State of Utah
Division of Oil, Gas and Mining
Utah Coal Regulatory Program

Technical Analysis and Findings

Wellington Prep Plant
ACT/007/012
July 25, 1996

WELLINGTON PREP. PLANT PERMIT AREA

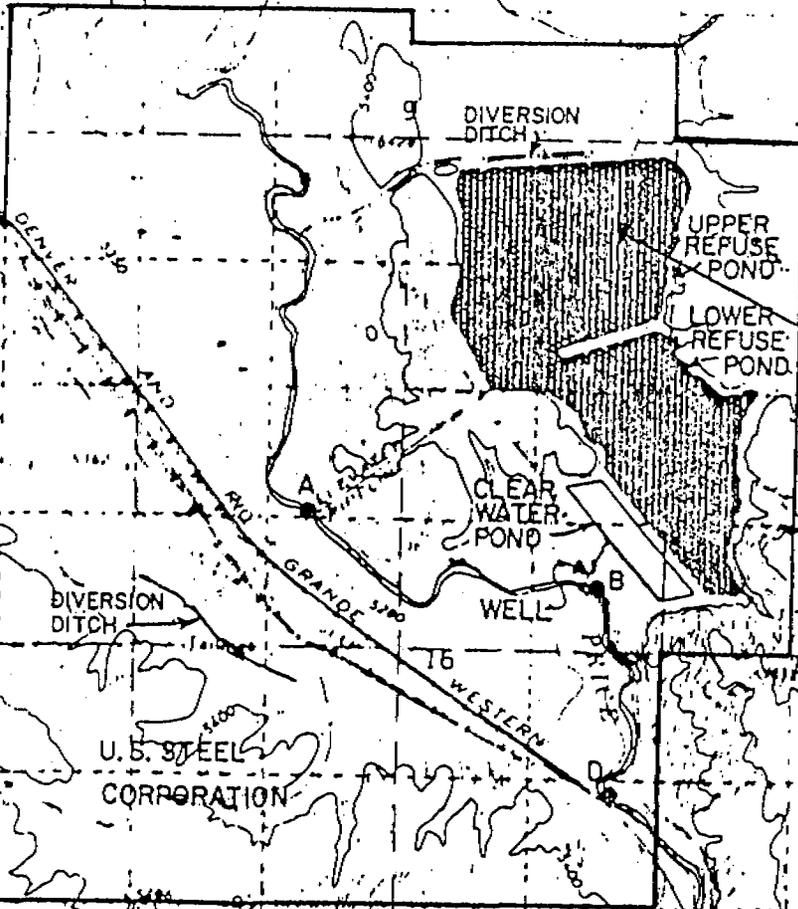
- R645-301-542.400**, provide a certified design that accounts for the factor of safety for the reclamation refuse impoundment at the base of the clear water pond and any other potential failure surfaces such as the upstream end of the site for the proposed reclamation configuration and show that the site meets requirements for a permanent coal mine waste disposal facility. 80
